UNITED STATES PATENT AND TRADEMARK OFFICE

APPLICATION NO.	FILING DATE	FIRST NAMED INVENTOR	ATTORNEY DOCKET NO.	CONFIRMATION NO.
10/014,991	12/11/2001	Gregory E. Sancoff	ONUX-4 CON	4207
23628	7590	03/07/2007	EXAMINER	
WOLF GREENFIELD & SACKS, PC FEDERAL RESERVE PLAZA 600 ATLANTIC AVENUE BOSTON, MA 02210-2206			BUI, VY Q	
		ART UNIT	PAPER NUMBER	3734
SHORTENED STATUTORY PERIOD OF RESPONSE	MAIL DATE	DELIVERY MODE		
3 MONTHS	03/07/2007	PAPER

Office Action Summary	Application No.	Applicant(s)	
	10/014,991	SANCOFF ET AL.	
	Examiner	Art Unit	
	Vy Q. Bui	3734

DETAILED ACTION

Fig. 3

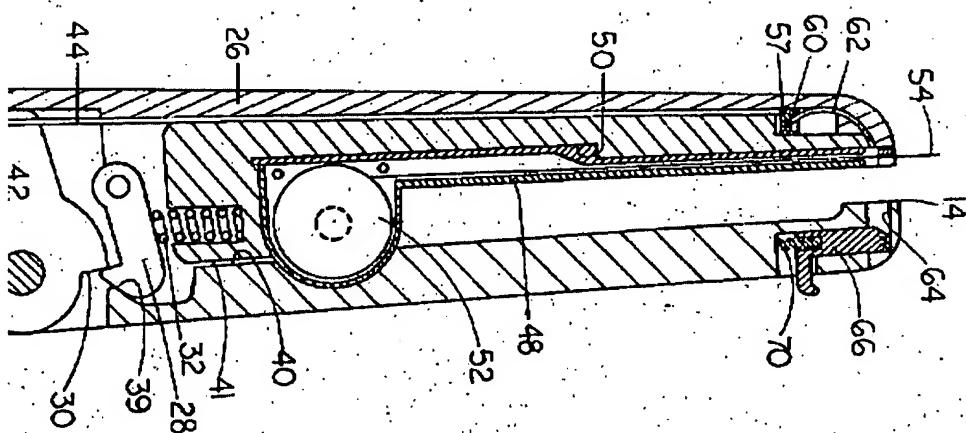
Claims 68-70 and 72 are rejected under 35 U.S.C. 102(b) as anticipated by Schweizer-3,842,840.

As to claims 68-70 and 72, Schweizer-'840 (F. 1-8) discloses suture cartridge 48 removably attached to suture instrument 10, suture wire 54, suture wire holder 52, a

suture wire housing covering suture holder 52, a drive mechanism including elements 44, 57 and needle 62 to draw the suture from the holder and move the suture along guide path way 48 defined by elongated suture wire guide as recited in the claims.
